#### Development Services Department

#### **BOARD ACTION REPORT - APPEALABLE ITEM**

Project Name: The George

**Project Location:** 655 George Bush Blvd **Request:** Class V Site Plan Modification

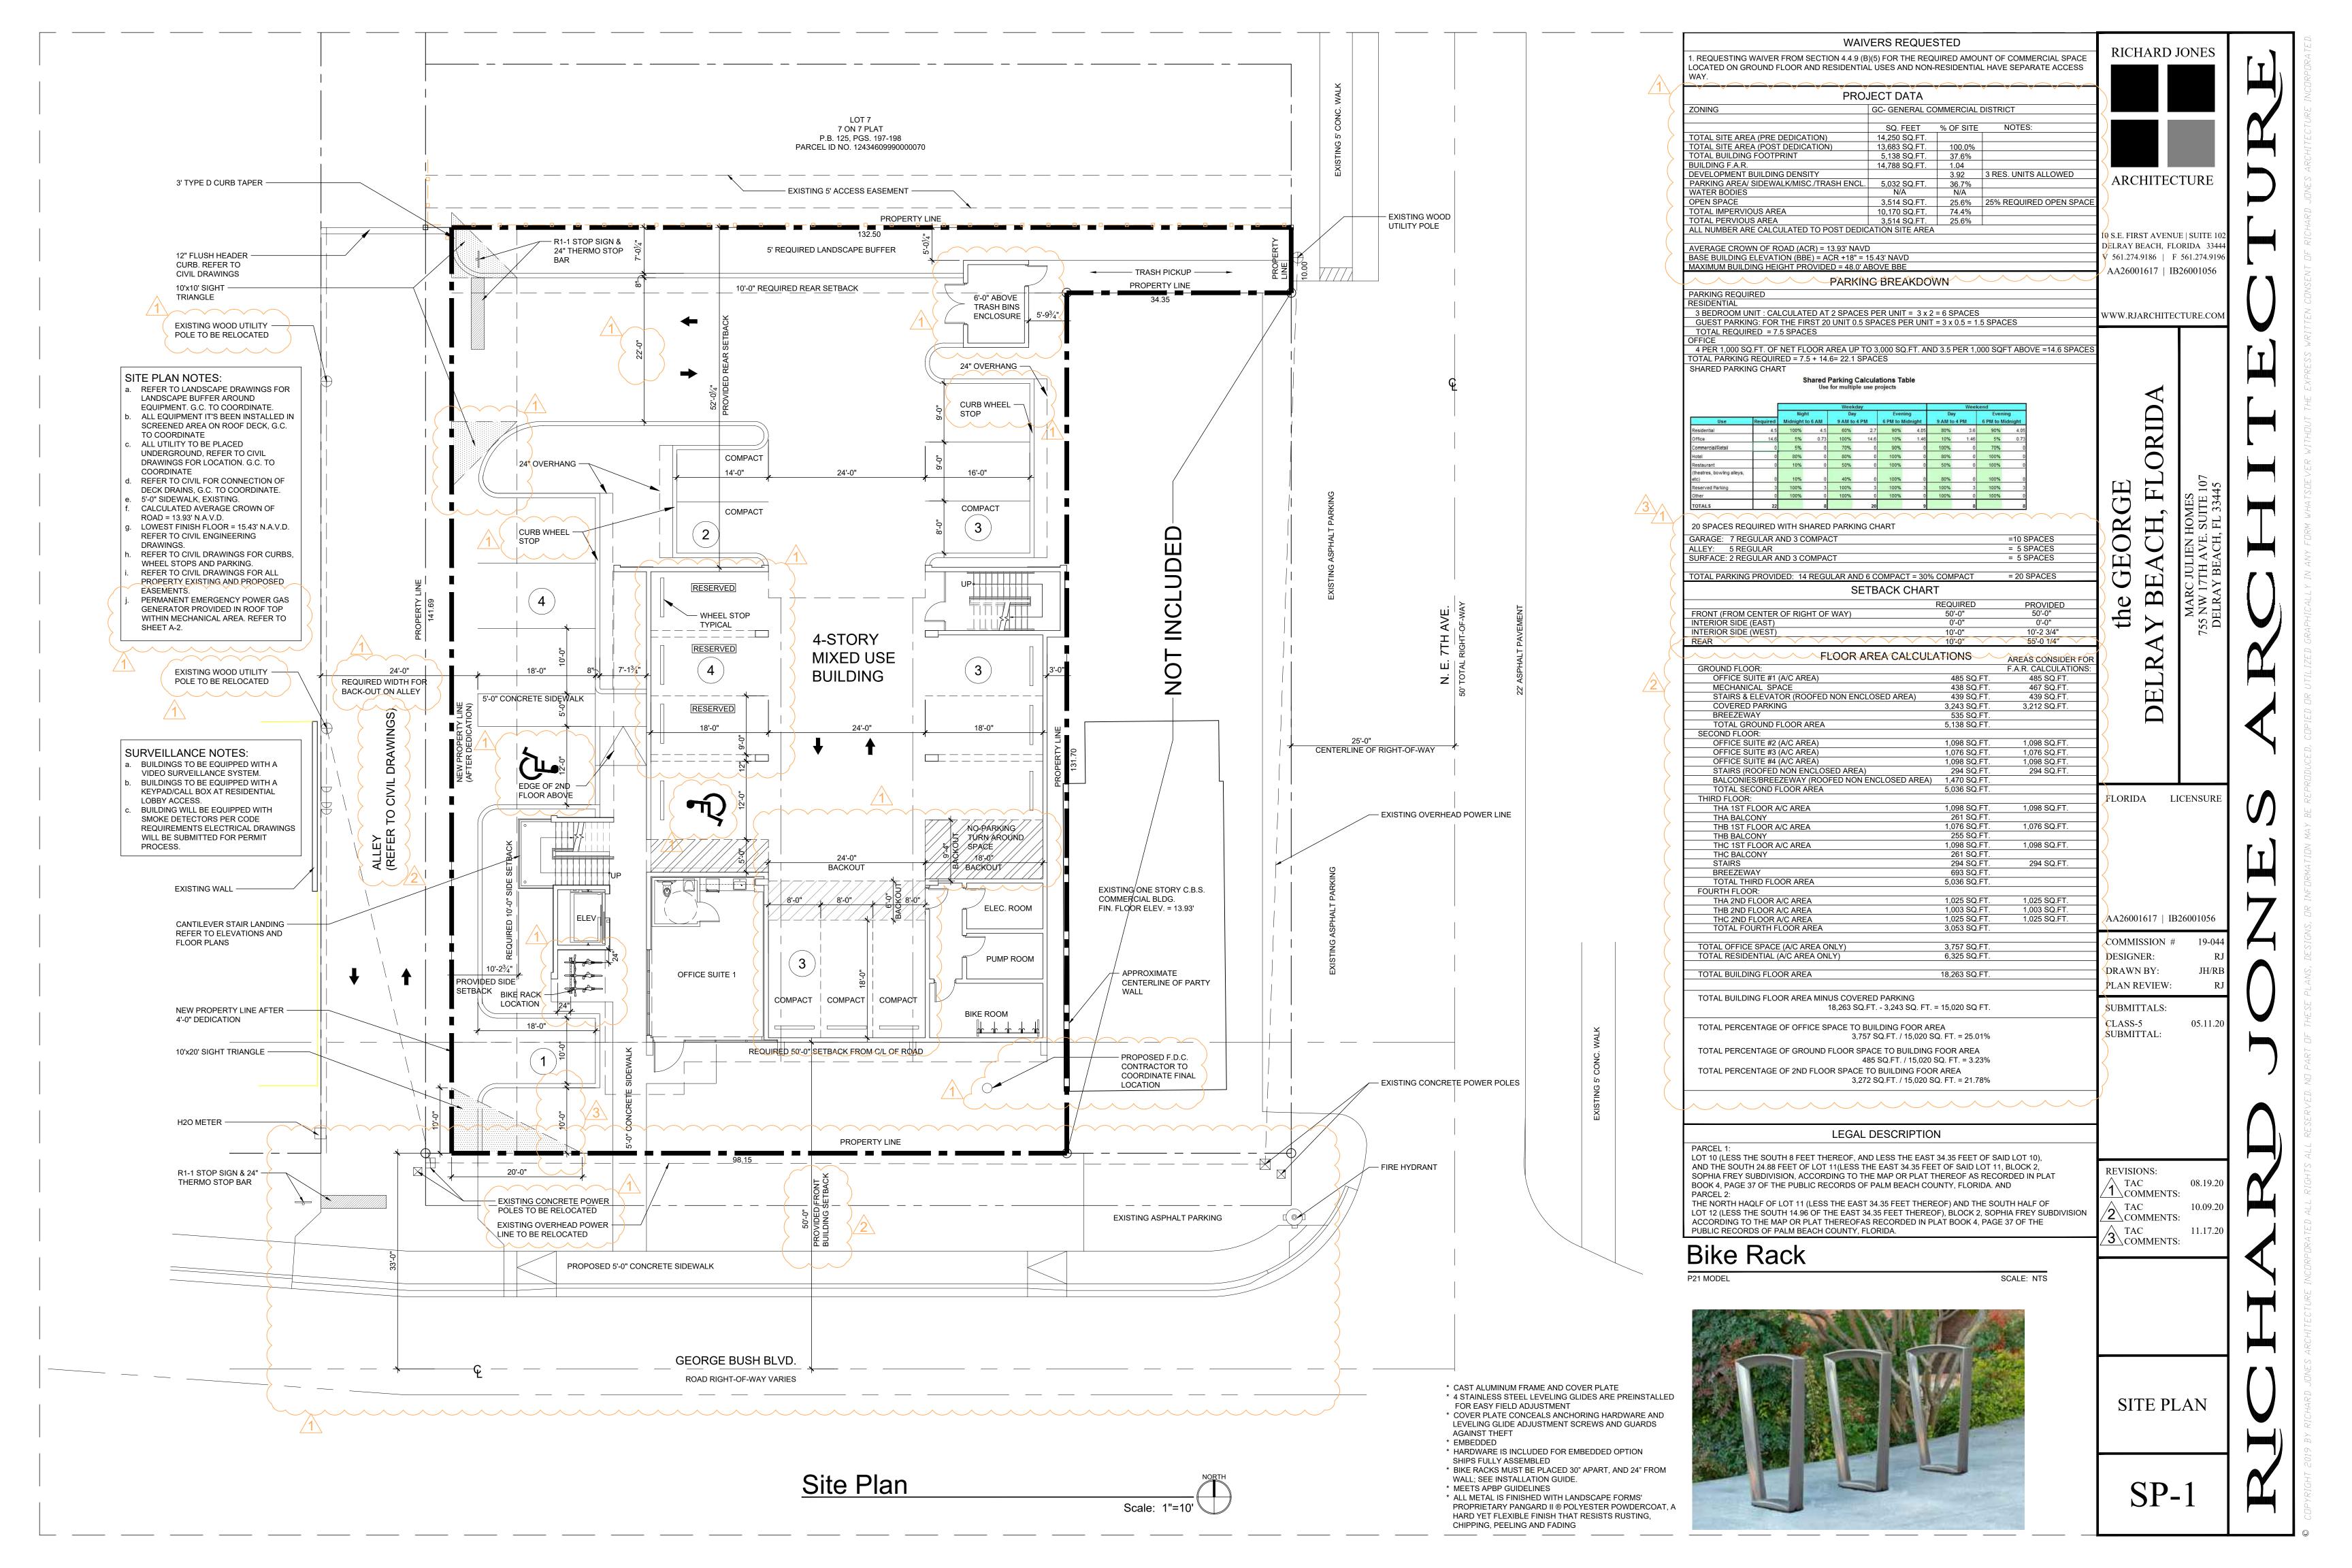
First, the design appears as though there will be some type of separation (3') between the exterior western wall of my client's building and the building to be constructed. We are unsure what this separation is for and what effect this will have on our building. We are trying to understand what the purpose of it and I would appreciate if you could provide us with some type of explanation.

Fourth, in the northeast portion of the property, there is a narrow entrance from N.E. 9th Avenue (described on the plan as trash pickup). What buffering is being provided to ensure that the trucks utilizing this entrance to collect the garbage and trash, will not interfere with the quiet enjoyment of the backlot of my client's property. Is there any intention to build a wall? I do not see it on the plans.

Fifth, in noting the eastern boundary of the proposed plan, there appears to be a stairwell which connects to my client's western wall. This configuration (at least from what I can see on the plans) would mean that anyone accessing the west wall would have to go around to the other side of the building in order to do so (in other words, this stairwell blocks the continuous ability to walk up and down the west portion of the wall.

Since there will now be open space on the western wall of my client's property, we will need some type of easement so that we will have access to that wall over the George Property (this was not necessary before because the wall abutted the western wall of my property – now that it is not, it will require a different type of maintenance, etc., and access must be provided, as part of the approval, for my client to reach that portion of his property.

Are there provisions being made to replace the wooden fence on the rear western boundary line of the property. With the intensity of the building being constructed, some requirement should be imposed to build a wall in its place.

Prior to the board making the final motion on the item, the agent of the applicant (Richard Jones Architecture) requested that the board provide a brief recess so they can contact their client regarding the easement request from the neighboring property. The board motioned and provided a 10-minute recess. Once the meeting reconvened, the agent stated that they spoke with their client and they would be willing to work with their neighbor to provide the easement.
